Project IEEE 802.16 Broadband Wireless Access Working Group <<http://ieee802.org/16>>

Title Frame structure consolidation for IP broadcast

Date Submitted 2005-11-13

Abstract Consolidate the frame structure of the IP broadcasting frame in 16h, to make it compatible for IPv6 and future extension

15.2.1.1.5 CTS Frame Structure

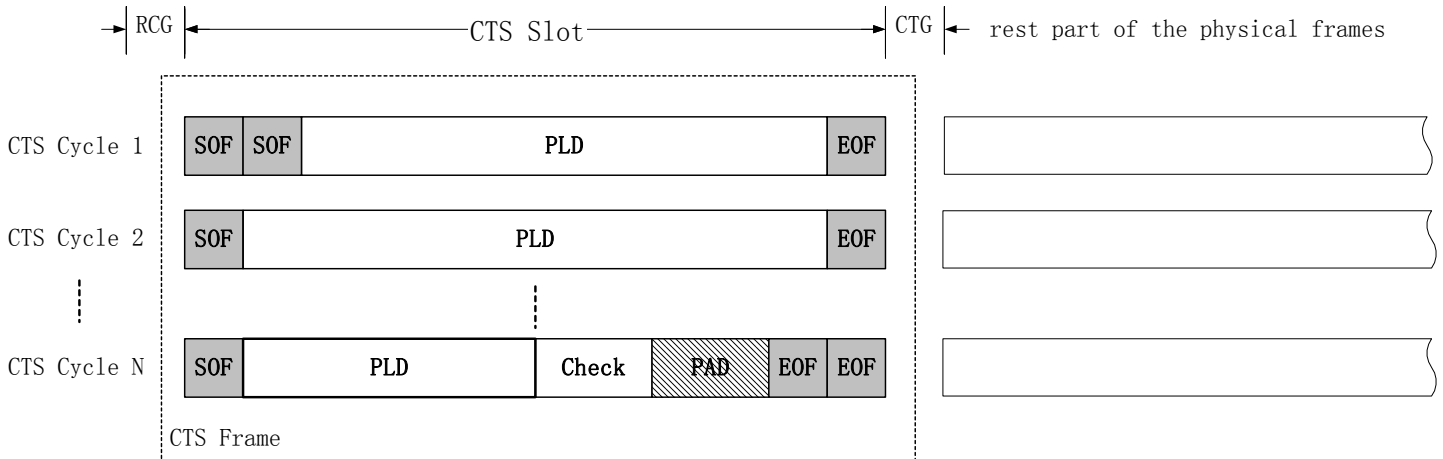
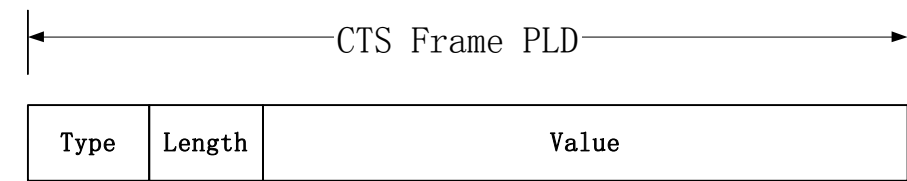
The CTS frame Structure and IBS_IPBC message frame is proposed in the working document and call for future contribution. Since this frame structure is not easy compatible for future usage, this paper give some modification to consolidate the frame structure to us in the CTS. The original text is shown below:

Proposed Text changes in working document:

[insert the following paragraph into section 15.2.1.1.5]

CTS frame is broadcasted from the base station to coexistence neighbor's subscriber station. They are loaded into serialized CTS slots. It consists of power keying energy symbols as basic element and carry the information from BS to the coexistence neighbor's SS. The CTS frame has the <SOF> symbols and <EOF> symbols as the boundary of slots, and two consecutive <SOF> and <EOF> indicate the message boundary, it shall be filled with symbol one in the rest part of last slots which have not enough payload and checking appendant. ~~and~~ CTS frame should be continuously carried in the serialized CTS slots during the whole CTS frame structure. Each CTS frame shall have 8 bits cyclic redundancy check (Polynomial "X⁸+X²+X+1") ~~data~~ appendant to check the validity of the information carried in the CTS frame. The basic structure is shown below:

The PLD (payload) part of the CTS frame should be divided into TLV aspect. TYPE indicate the type of the payload, LENGTH correspond to the number of symbols/bits contained in the VALUE portion. (TYPE and LENGTH is 1 octet each.)
